**Subject: Cell 1 and Landfill Site Certification Addendum 2
and Responses to Department Certification Comments
Enterprise Recycling & Disposal Facility
Angelo's Aggregate Materials, Ltd.
FDEP Permit Nos. 177982-001-SC, 177982-002-SO
Pasco County, Florida**

On behalf of Angelo's Aggregate Materials, Ltd. (Angelo's), Hartman & Associates, Inc. (HAI) is submitting responses to the Department's comments, dated December 8, 2003, regarding the certification submittals for the above referenced facility. Our responses are based on the discussion from our meeting with the Department on January 5, 2004. For your convenience, your comments are stated first with our responses, when applicable, following.

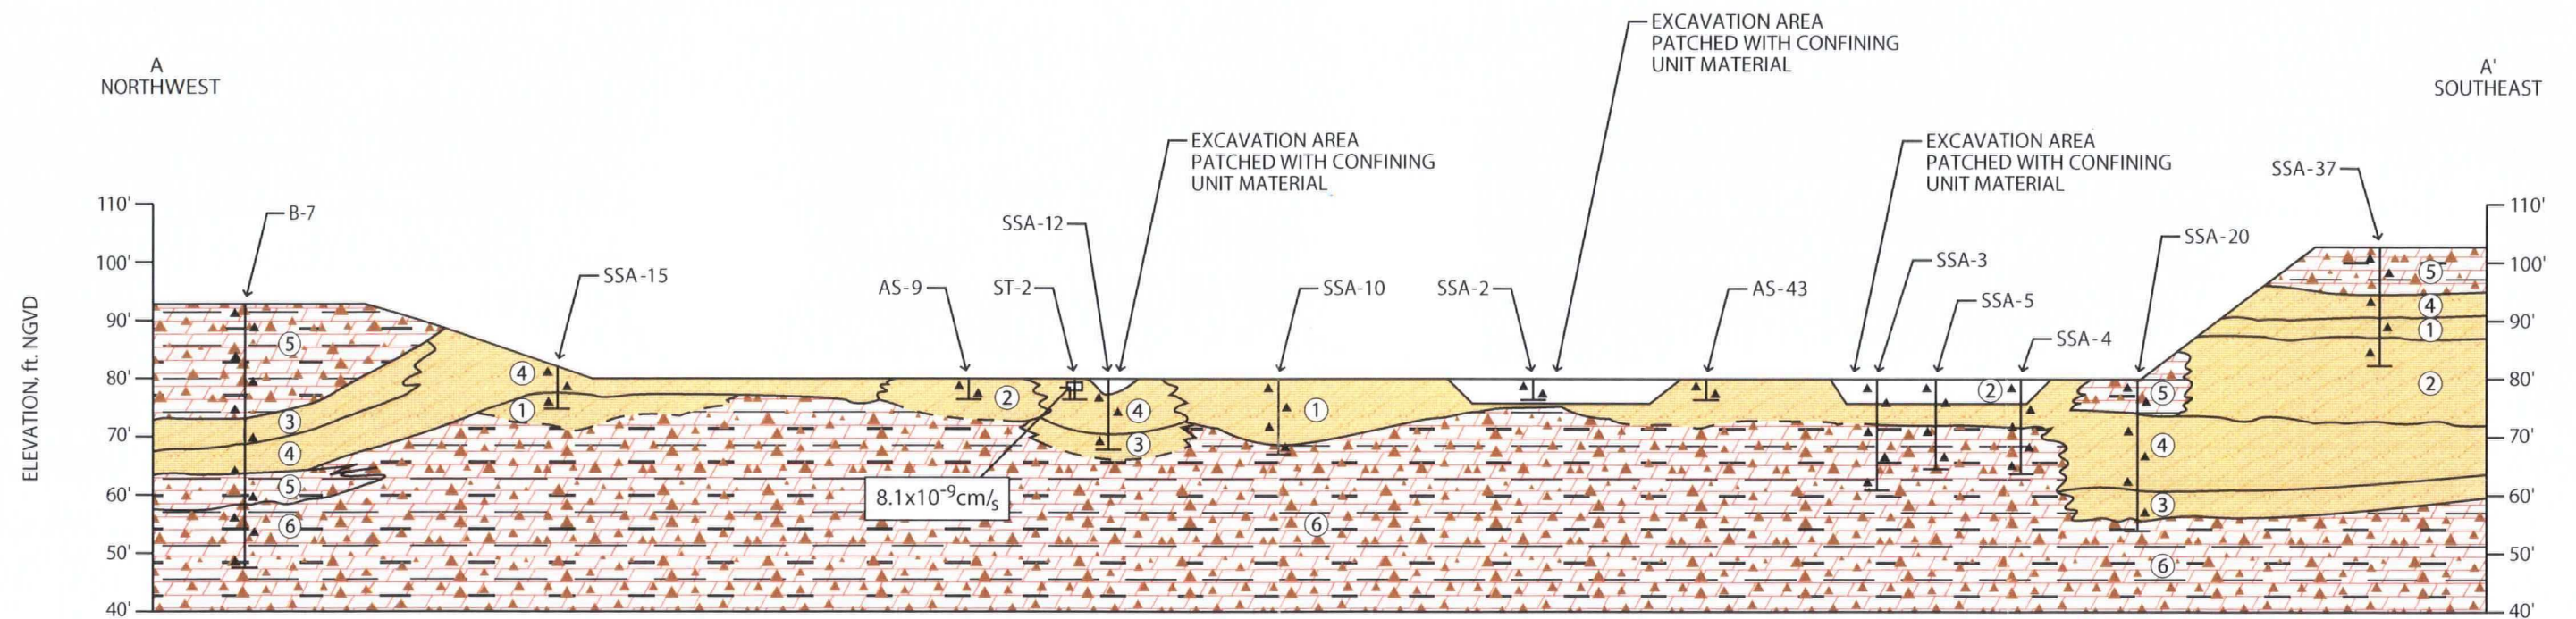
- k) **Appendix A, Figure 1 (map of borings)** - *[There are very few borings shown on this figure that include the boundaries of the cells, and there are no borings located on any the part of the selected cross-sections shown on this figure that include the boundaries of any of the cells. Only those areas that have been completely excavated and confirmed to have the specified clay layer/confining unit should be certified. All cross-sections must include borings shown for the certified area in order to include the entire certified waste disposal area for approval. All borings that represent the lithology in the vicinity of each cross-section, and the lithology for each of the detection well locations in the vicinity of the cross-section, should be included on the selected cross-section to show the continuity of the clay layer/confining unit. The degree of accuracy (for example: +/- 20 feet) must be provided for the boring locations. Related comments are provided in items 1)l), 1)m), and 1)n) of this letter.]*

Response: Figure 1 has been revised to include a line connecting the cell markers that indicate the areas to be certified at this time. Any changes to the cross-sections that were necessary to intersect this line have been made. The revised cross-sections are attached in Appendix A. A note referencing the signed and sealed survey sheets, provided by Foresight Surveyors, for the boring locations has been added to the Figure 1.

CELL No. 1- CROSS-SECTION A-A' - CERTIFICATION
ENTERPRISE RECYCLING AND DISPOSAL FACILITY
DADE CITY, FLORIDA

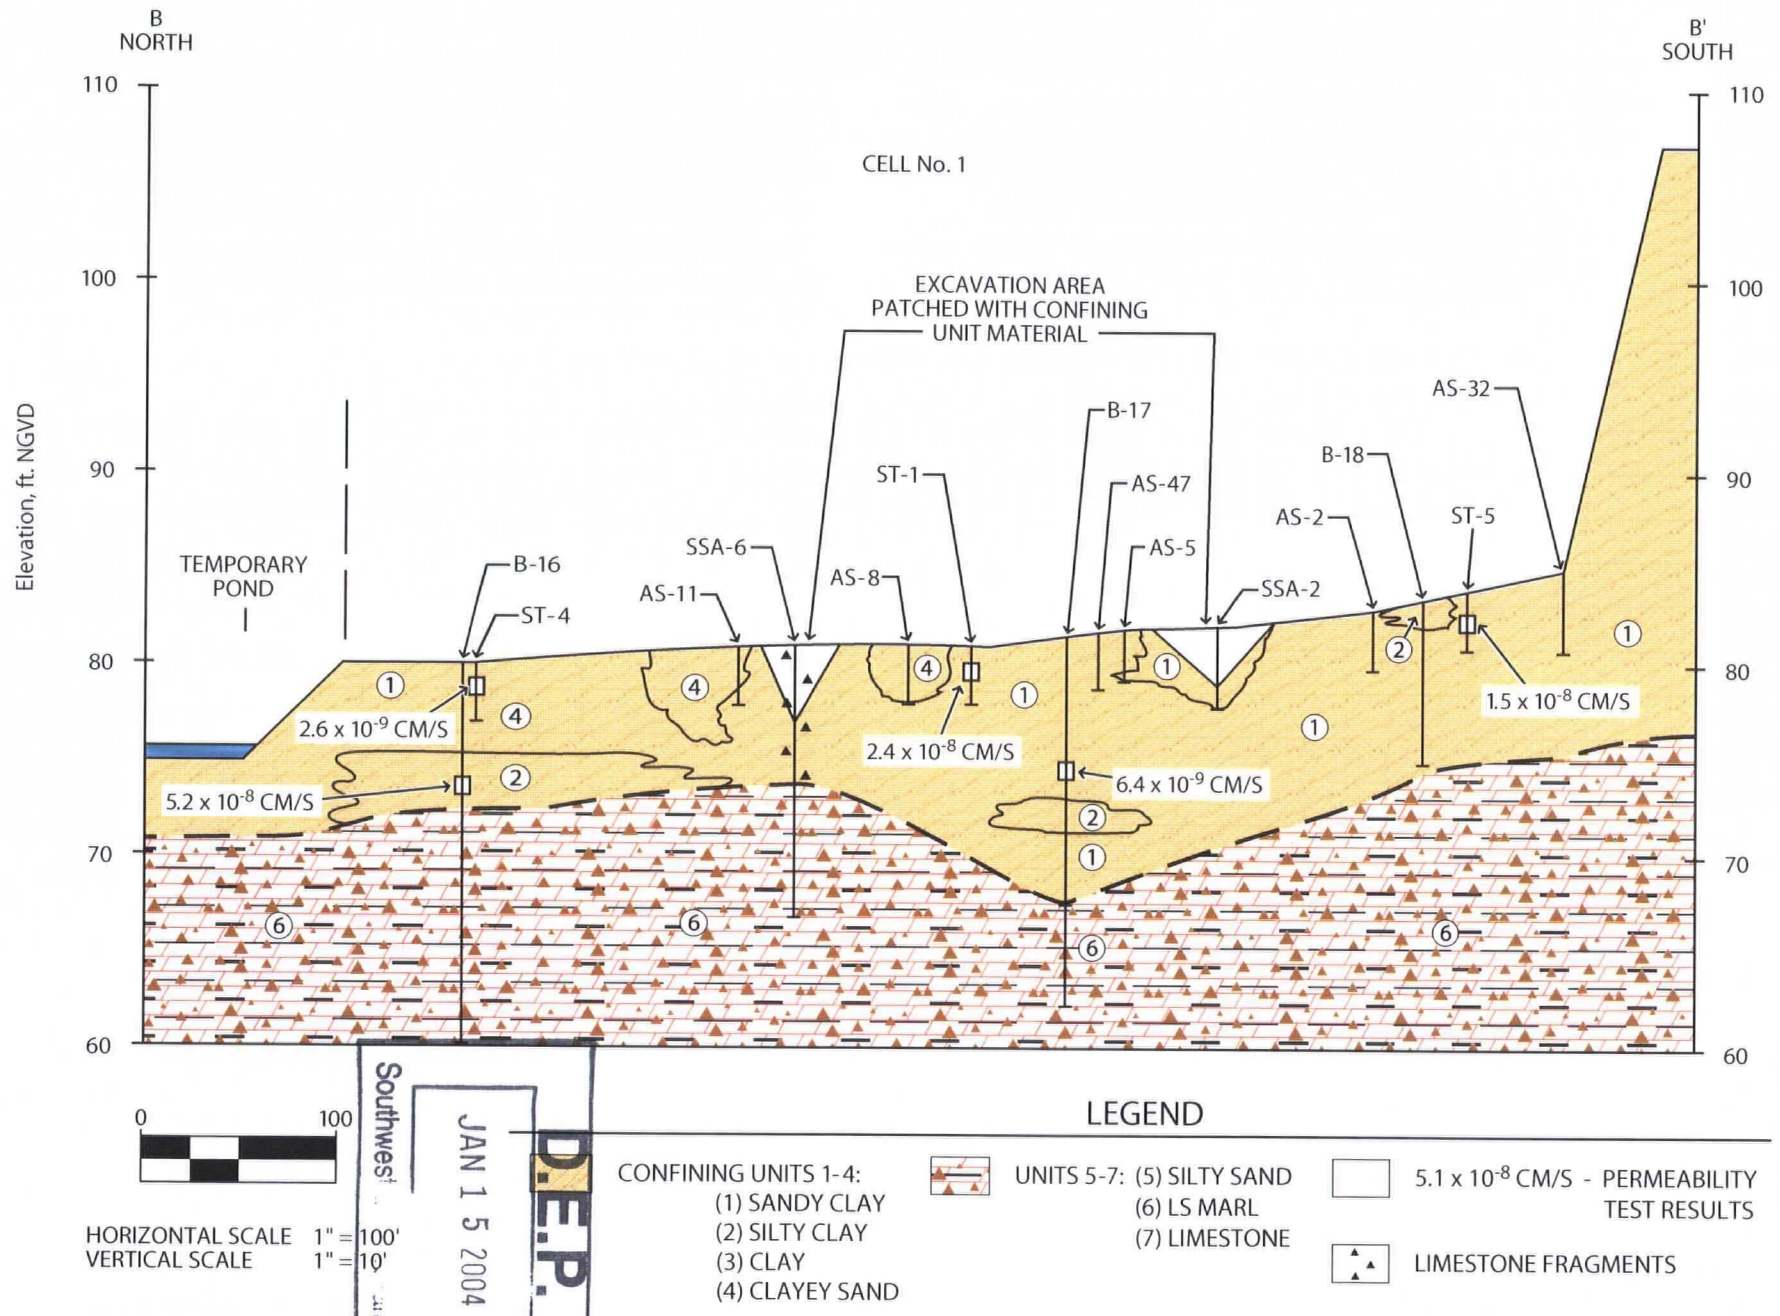
Figure 1, cross-section A-A' (Scale: 1"=100'H, 1"=10'V) - *[This cross-section shows only one permeability test for 6 deeper borings. This cross-section shows silty clay on the southeast slope with no borings and no borings on the cell base/floor along the west side for 350 feet from ST-2. This cross-section should show many of the "AS" borings and others (B-17 and SSA-11), and should be extended to the east to include SSA-20 and SSA-37.]*

Response: It is common in geologic practice to continue cross-sections for a limited depth beyond the extent of borings to represent the likely soil conditions of a site. However, the cross-sections have been revised to include notation (question marks) where appropriate to demonstrate that no deeper borings were completed to confirm the presence of the indicated soil types. The cross-sections do not end at the last included borings since soil types and extents are generally extrapolated in both directions from each boring to the midpoint of the distance to the next. This is done based on knowledge of the site characteristics and available site data. Additional boring locations have been included as discussed during the January 5 meeting, to extend the cross-sections and maximize the areas to be certified. Some AS and SSA borings were added to the cross-sections as deemed necessary by HAI. Each cross-section is shown to depict the geology through a horizontal distance and a vertical elevation. The horizontal distances vary and therefore different scales are required to provide magnification and clarity for ease of evaluation. It was agreed between HAI and the Department through e-mail correspondence that the scales would not be revised. This response is intended to address the entire 1)n) comment, and therefore, each individual component will not have an individual response.

**CELL No. 1 - CROSS-SECTION B-B' - CERTIFICATION
ENTERPRISE RECYCLING AND DISPOSAL FACILITY
DADE CITY, FLORIDA**

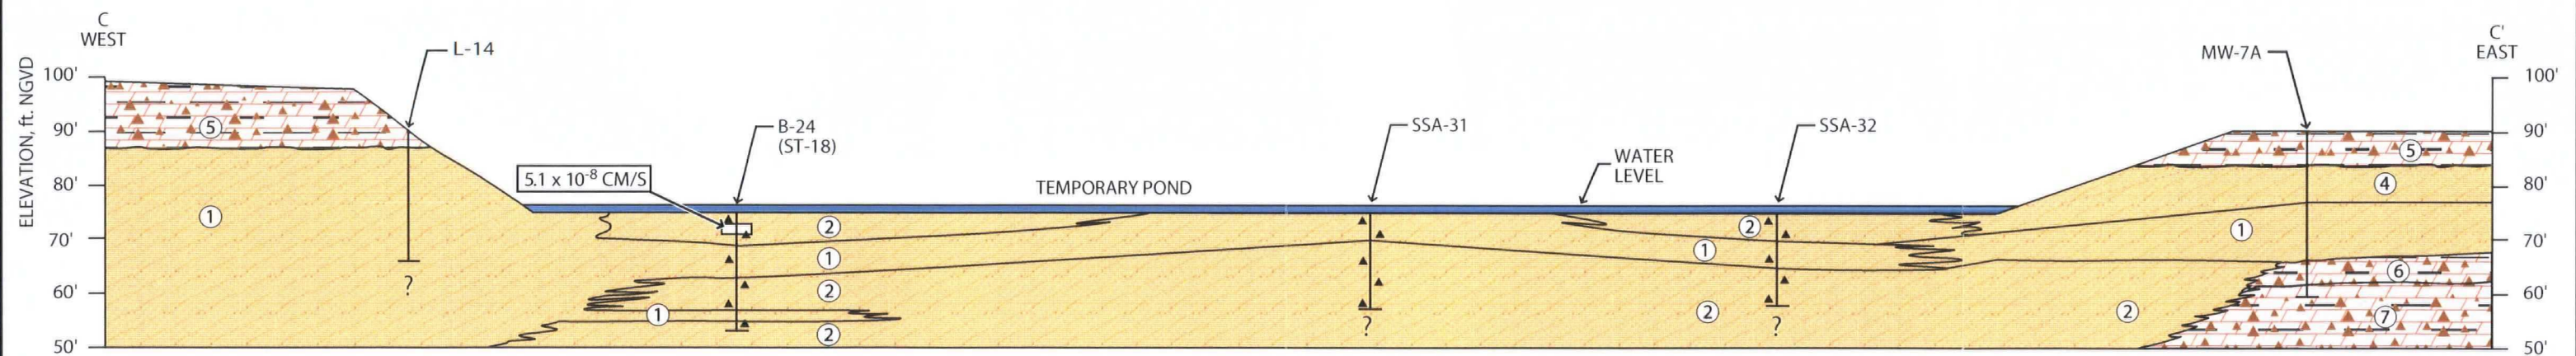
Figure 2, cross-section B-B' (Scale: 1"=100'H, 1"=10'V) - *[This cross-section shows no boring for the south edge of Cell 1, or for the north edge. This cross-section provides more information, permeability tests, more borings, and is more helpful, and shows more clay layer/confining unit continuity. This cross-section should show many more of the "AS" borings and others (such as SSA-24).]*

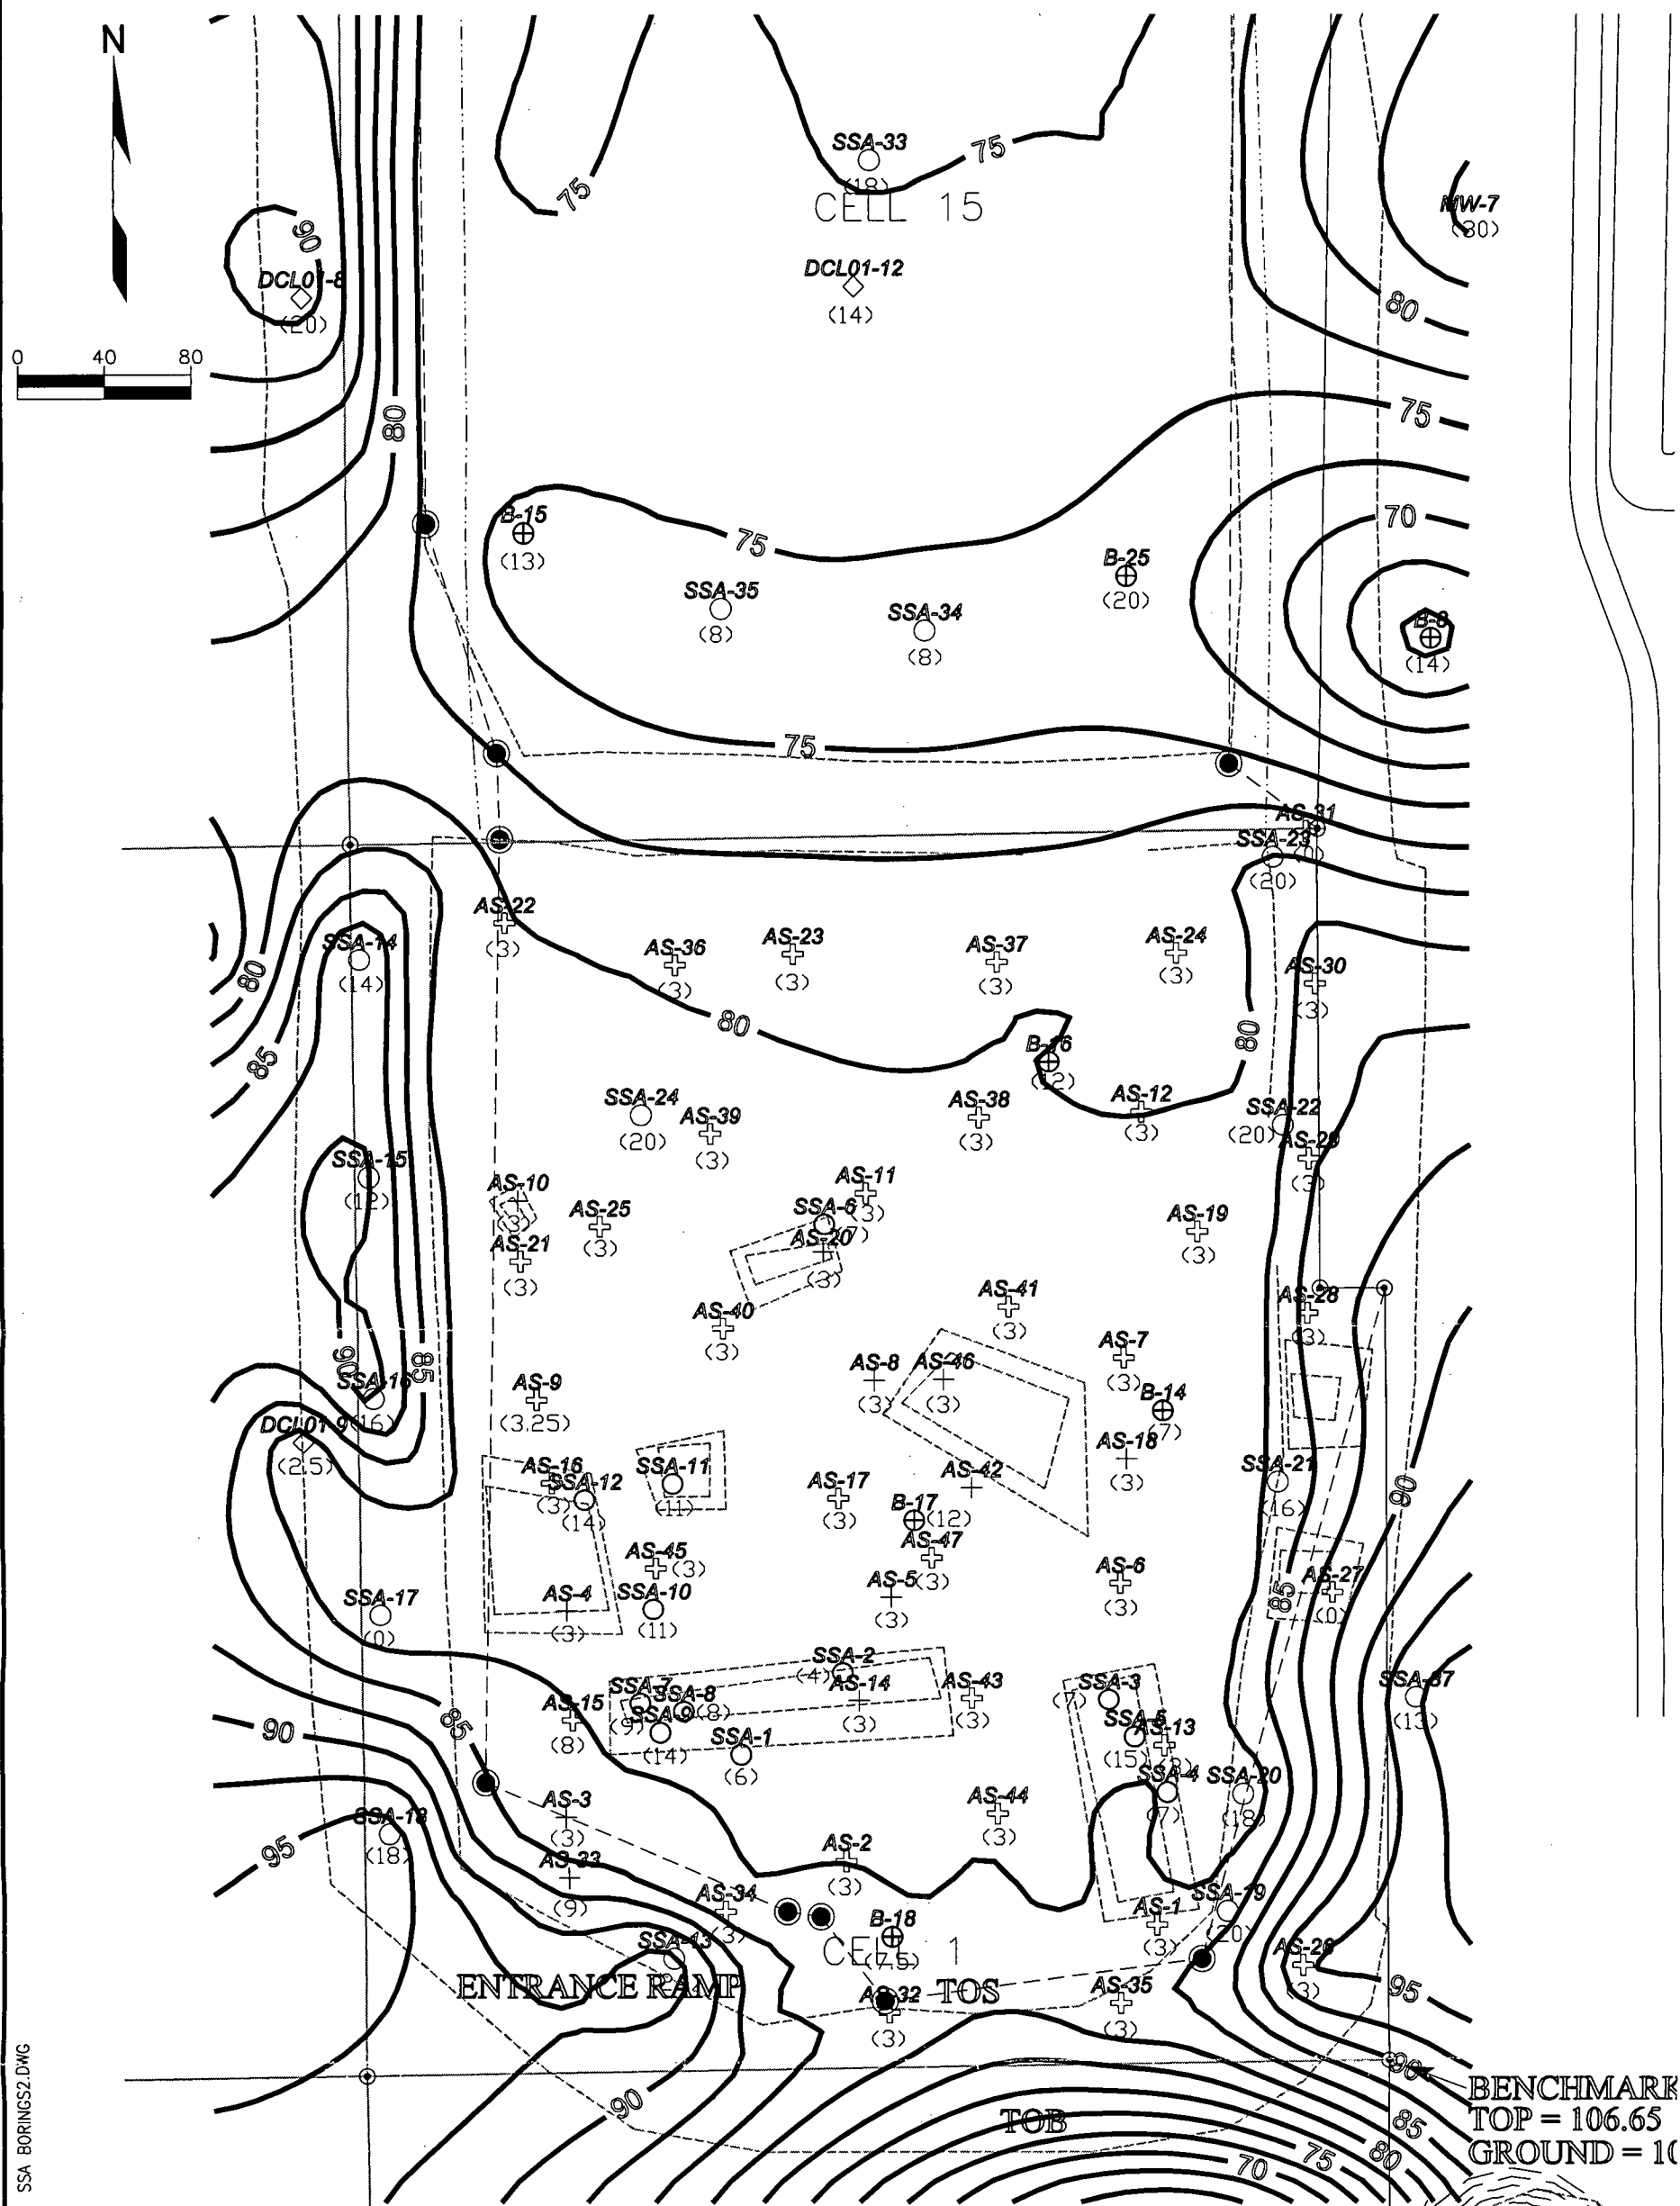
Figure 38 (Cell 1 clay layer/confining unit contour map) - *[This figure/map is based on a topographic survey (with both horizontal and vertical control) and is intended to show both the Cell 1 clay layer/confining unit contours and the locations of specific features (borings, the limits of the excavated cells, and test pits/excavated areas). This figure/map shows that portions of the top of the clay layer/confining unit is at elevation +85 (3 feet above the surface) and higher, the cells (sideslopes) are not completely excavated, and no corner posts are shown for the limits of waste disposal. Boring B-18 is missing from this drawing. All borings must be shown on all top of clay layer/confining unit contour maps, or a specific reason provided for each excluded boring. This figure shows the excavated area for "AS-10" to be extremely small in comparison to the size of other excavated areas, and the location of boring "AS-42" is not shown within the excavated area. Additional borings should be provided in the vicinity of these two areas to confirm the presence of the clay layer/confining unit. The corner posts appear to be located at the cell boundaries and in areas along the toe of slope that have not been confirmed to have the specified clay layer/confining unit. The certified area should be provided on one drawing (drawn to scale) and limited to the area completely excavated and prepared for waste disposal, and the limits of waste disposal/certified area must be marked by corner posts. The scale of 1"=100' appears to be incorrect and must be corrected. This drawing must be corrected prior to the approval for Cell 1. A scale of 1"=60' is suggested, the same as for the cross-sections. Related comments are provided in items 1)k), 1)l), and 1)n) of this letter.]*

Instances where the thickness of the confining unit within Cell 1 as shown on Figure 38 in the HAI submittal dated October 8, 2003 is subject to revision if acceptable confining materials are determined by using at least 37% fines and clayey sands are excluded unless supported by a sieve test are summarized below:

Response: Figure 38 has been revised as discussed during the January 5 meeting to demonstrate the presence of the required confining material within the designated area to be certified. The limits of certification are included in this figure as a dashed line in Cells 1 and 15. The excavated area for "AS-10" was excavated to the extent that confining unit material was identified on each wall and suitable as tie-in material. The location for "AS-42" was confirmed to be within the excavation area. The contractor surveyed many of the excavation areas as simple geometric shapes to facilitate the excavation volume calculations. The scale of 1"=100'

has been replaced with a scale of 1"=80'. The scale used for this figure was chosen to display the area of interest in a standard 11" x 17" format
